STAFF RECOMMENDATION

116 Cherokee Road

February 17, 2016

Application: New construction - addition

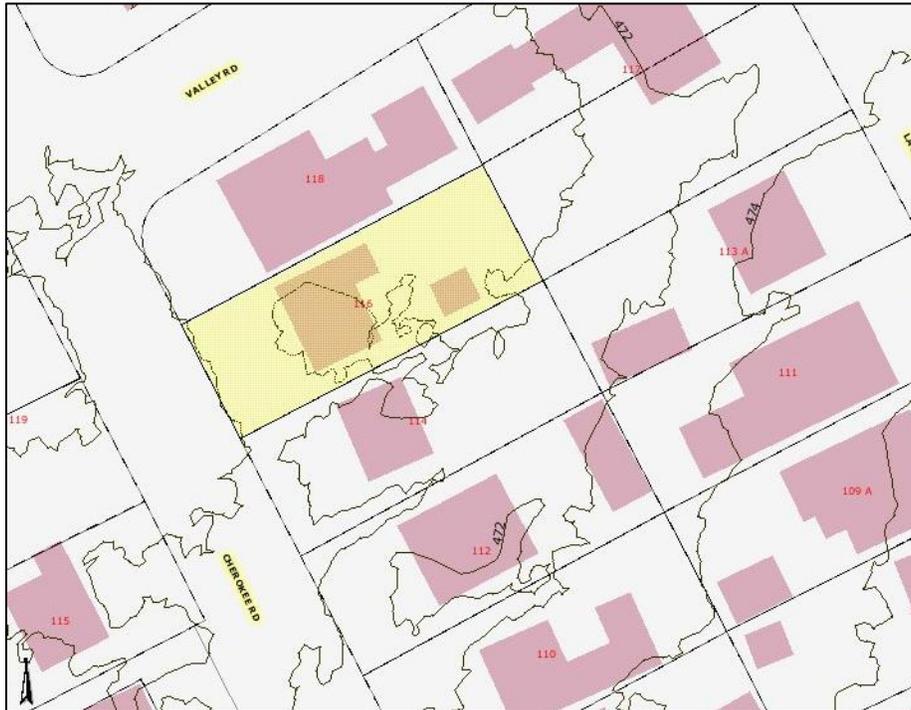
Figure 2: Existing front stoop appears to be original.

The proposal would also add a Tuscan portico, eight feet (8') wide and four feet (4') deep, to the front of the house. While this type of feature is not uncommon for Colonial Revival houses, there is no indication that this house had such a feature historically. Reconstructing a missing architectural element would be appropriate, but adding one conjecturally is not. Staff therefore finds that adding the portico would not meet sections II.B.2.a and II.B.2.e of the design guidelines.

1 SITE PLAN
 A-1 SCALE: 1"=20'-0"

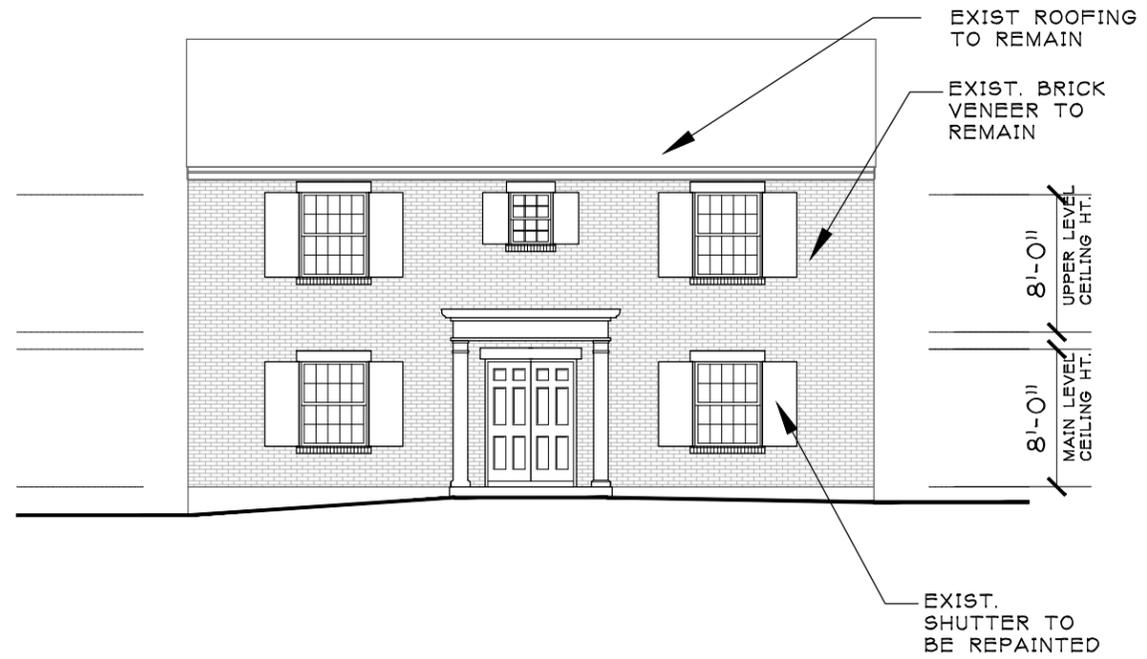
Setback & Rhythm of Spacing: The addition will sit in sufficiently from the sides of the historic house such that it will meet the required setbacks and have no impact on the rhythm of spacing perceived from the street. Staff finds that the project meets section II.B.1.c of the design guidelines.

Appurtenances & Utilities: No changes to the site’s appurtenances were indicated on the drawings. The location of the HVAC and other utilities was also not noted. Staff asks that the HVAC be located on the rear façade, or on a side façade beyond the midpoint of the house. The project meets section II.B.1.i.

1 WEST ELEVATION
 A-2 SCALE: 3/32"=1'-0"

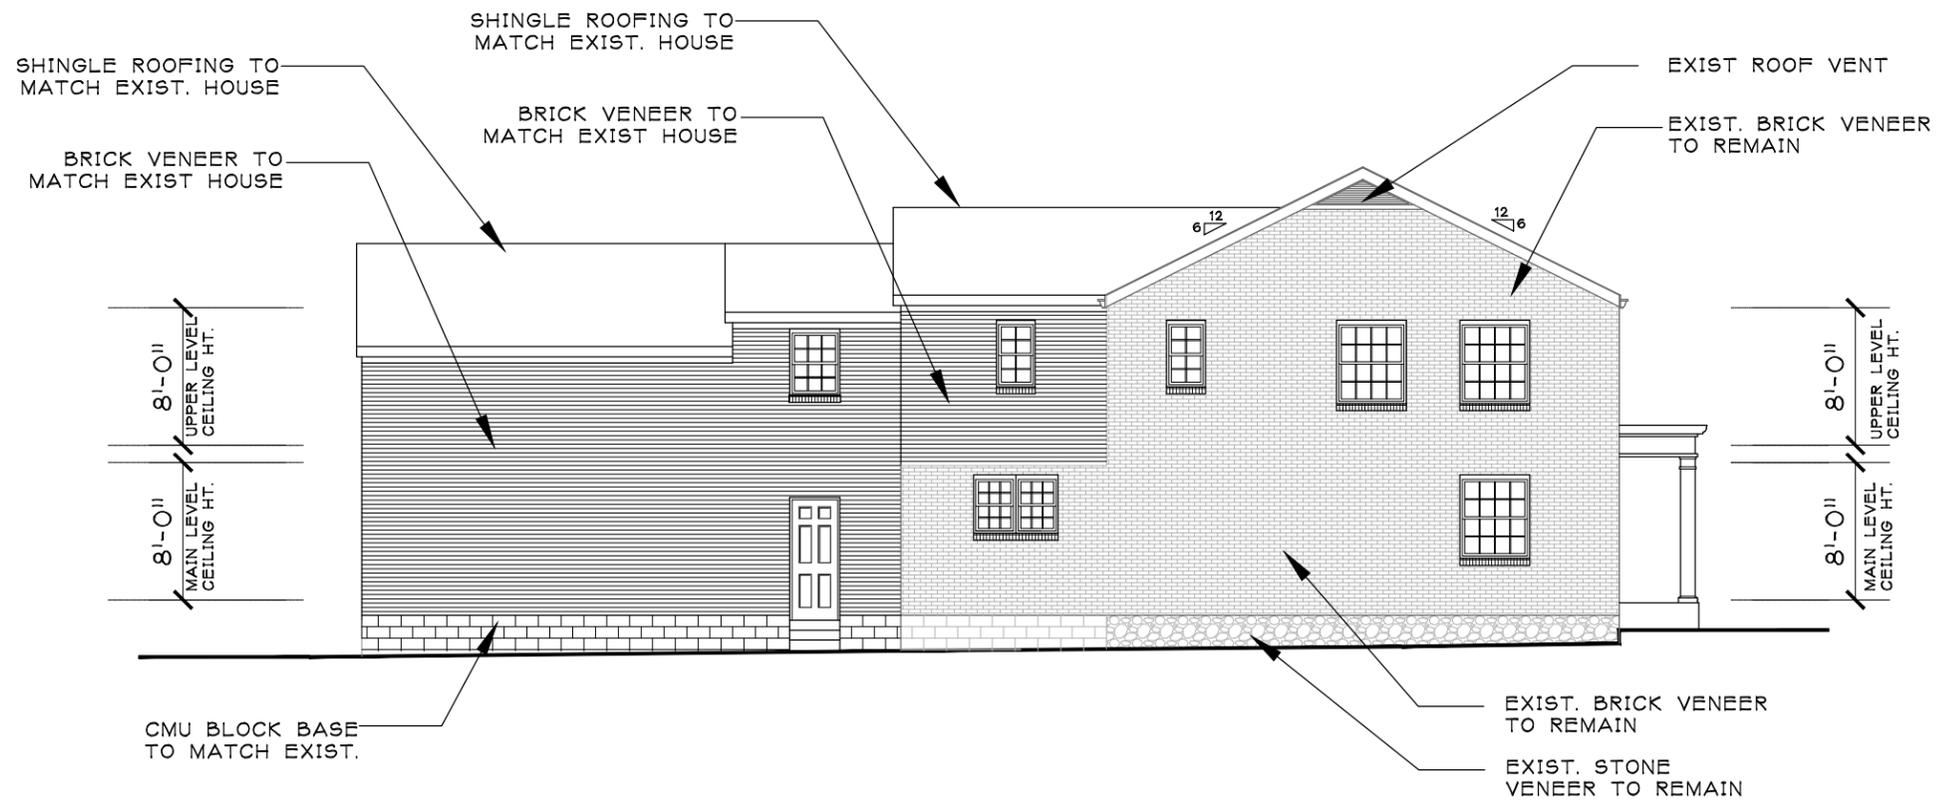
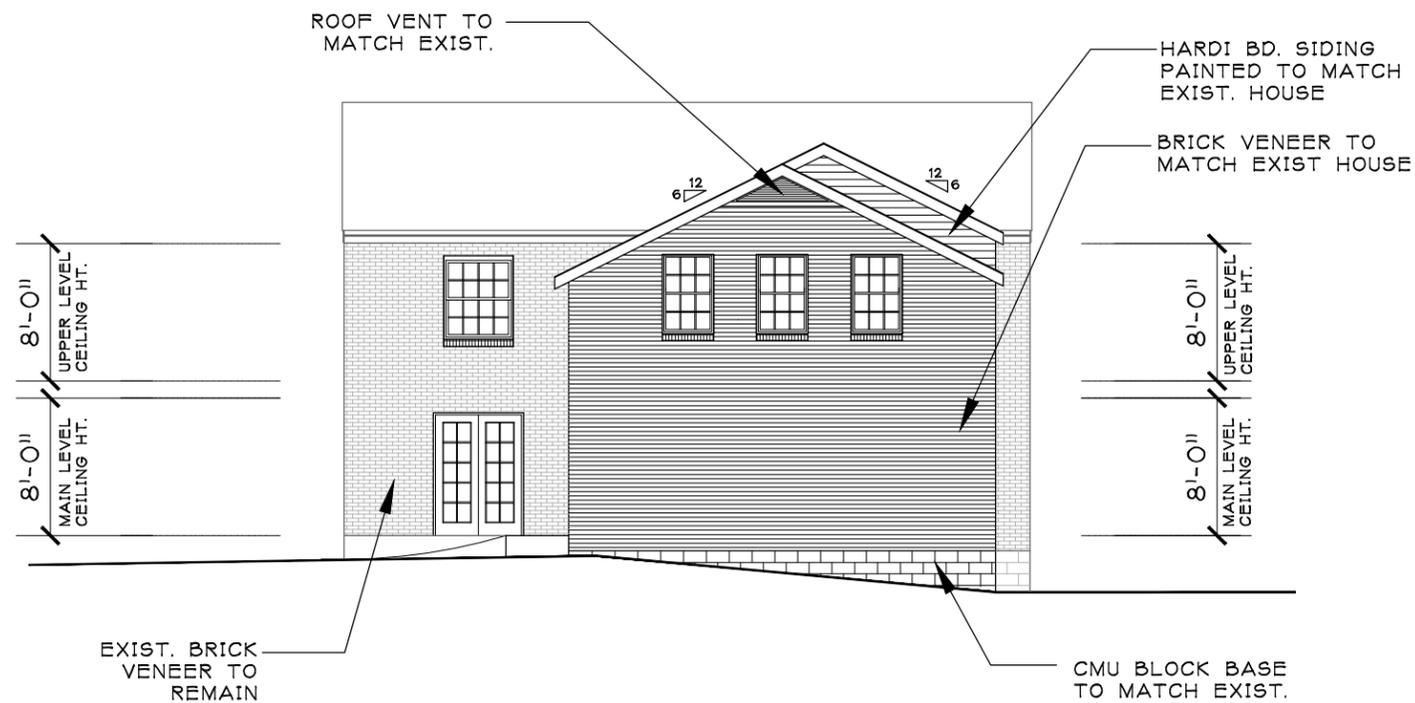
Location & Removability: The rear addition will add a second story to an earlier rear addition that is flush with the left side of the original structure, before stepping in two feet (2') and continuing to the rear. Typically additions should be fully stepped in in order to differentiate between an historic building and new construction; however, because there is an existing addition that does not step in Staff finds the proposed configuration to be appropriate. From the right side the addition will be stepped in thirteen feet (13').

The rear addition will extend back thirty-one feet (31'), with an eave line three feet (3') lower than the existing eaves and a rear-oriented gable roof four feet (4') lower than the original roof. With a lower roof and eave line, and by stepping in the side walls, Staff finds that the addition will be subordinate to the scale of the historic house. Staff finds the rear addition to meet sections II.B.2.a and II.B.2.e of the design guidelines.

Materials: The existing one-over-one windows on the house are not original, and they will be replaced with divided-light windows more appropriate for the Colonial-Revival style. The proposal would replace the existing front door with a new double-door. Staff finds this change to be inappropriate as it would require alteration of the original opening. Staff asks to approve all window and door selections prior to purchase and installation.

Roof Form: The roof of the addition will be a 6:12 gable, oriented to the rear. The addition includes a wall dormer, which is typically discouraged; however, in this case, the dormer sits back from the existing side wall by thirteen feet (13' and therefore will not likely be visible. This form matches the original roof, and therefore meets section II.B.1.e of the design guidelines.

Proportion and Rhythm of Openings: No other changes to the window and door openings on the existing house were indicated on the plans. The windows on the proposed addition are all generally twice as tall as they are wide, thereby meeting the historic proportions of openings. Although there would be an twenty-four foot (24') expanse of wall space without a window or door opening on the left side of the addition, this wall will not be greatly visible because it is stepped in from the side of the original structure. With the exception of the alteration of the front doorway, Staff finds the project's proportion and rhythm of openings to meet Section II.B.1.g.
